DEVELOPMENT ASSESSMENT UNIT
Minutes of the Development Assessment Unit
Shire of Augusta Margaret River
On 2 July 2019

DEVELOPMENT APPLICATION ASSESSMENT (DAU)
Report to Manager Planning and Development Services
Proposed Dwelling, Associated Retaining, Fill and Fence at 20 (Lot 338) Honeysuckle Glen, Cowaramup

Proposed Dwelling at 207 (Lot 135) Blackwood Avenue Augusta

Figure 1: Original Proposal

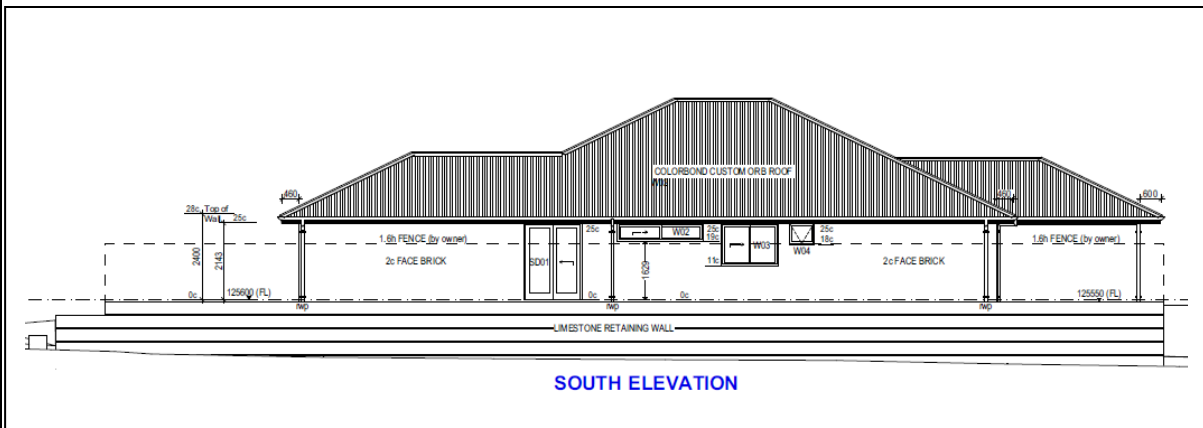
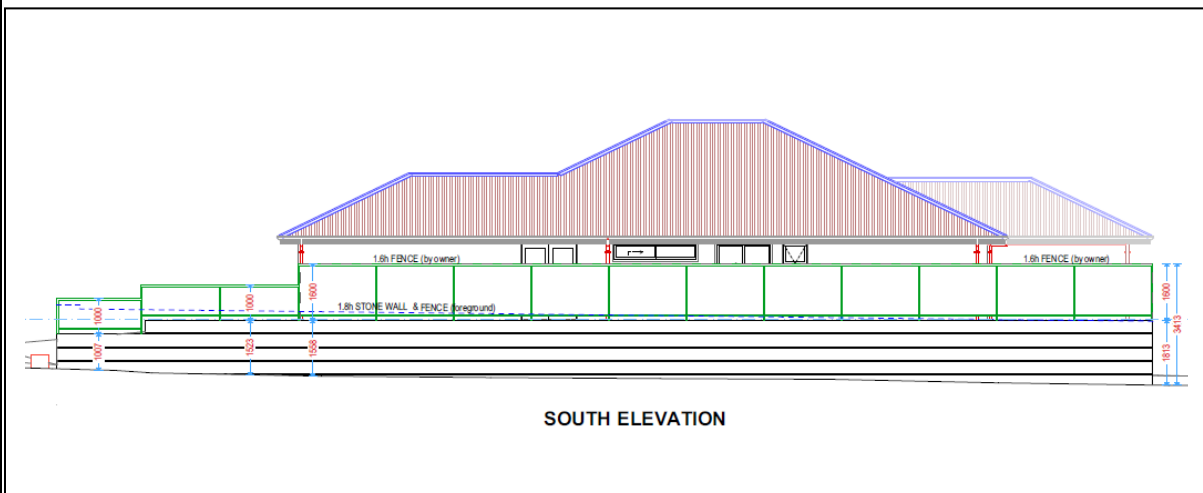
- This barrier will impact the visual amenity and will result in a significant loss of light and over shadowing on the adjoining southern property.
- The neighbouring southern property is orientated to the north with windows all along the northern side of the building. The proposal will result in issues of damp and overshadowing of this area.

Structure Plans and Local Development Plans (DAP)	
Is the land in any Structure Plan Area or subject to a DAP? <input checked="" type="checkbox"/> Yes <input type="checkbox"/> No	
West Cowaramup Townsite Strategy – no implications arise from this strategy to the proposal	
Advertising/Agency Referrals	
Has the application been referred to adjoining landowners/agency?	<input checked="" type="checkbox"/> Yes <input type="checkbox"/> No <input type="checkbox"/> N/A
Has a submission been received by Council?	<input checked="" type="checkbox"/> Yes <input type="checkbox"/> No <input type="checkbox"/> N/A No. received: 1
Have agency or authority comments been received?	<input type="checkbox"/> Yes <input checked="" type="checkbox"/> No <input type="checkbox"/> N/A
Submission	
<p>Concern: Concerns are raised with replacing an existing 1.6m high fence, with a retaining wall and 1.6m fence that will create a 3.2m high barrier on the northern boundary.</p> <p>Response:</p> <ul style="list-style-type: none"> - The applicant has submitted an engineering report to demonstrate that the Site is constrained by clay soils and granite outcrops which rule out excavation below the natural ground level for site works. Accordingly, the proposal relies on filling along the southern side boundary to create a developable area on site for the proposed dwelling. - The applicant has also amended the proposal (see Figures 1 and 2 below) in response to the concern raised. The front section of retaining has been reduced in height from 1.5m to 1m for a 2.5m section. The fencing has been reduced from 1.6m to 1m.

While the concerns raised during the advertising period are noted, justification for the site works has been provided and the proposal has been amended in response to the concern. The extent of fencing forward of the proposed dwelling has been reduced in height to 1m and retaining forward of the proposed dwelling has been stepped down to respond to the ground level, to reduce building bulk and overshadowing forward of the proposed building and reduce streetscape impacts. The proponent has also demonstrated, with submission of an overshadowing diagram, that the proposal will meet the deemed to comply standards of the R-Codes and will not cast shade over the northern openings on the affected neighbouring dwelling. Furthermore, it is also noted that the proposed retaining along the side boundary is necessary in this case for site works given soil conditions and is not out of character with the nature of works on adjoining sites in the street. For these reasons the amended proposal is considered to have responded to the concerns raised during the notification period.
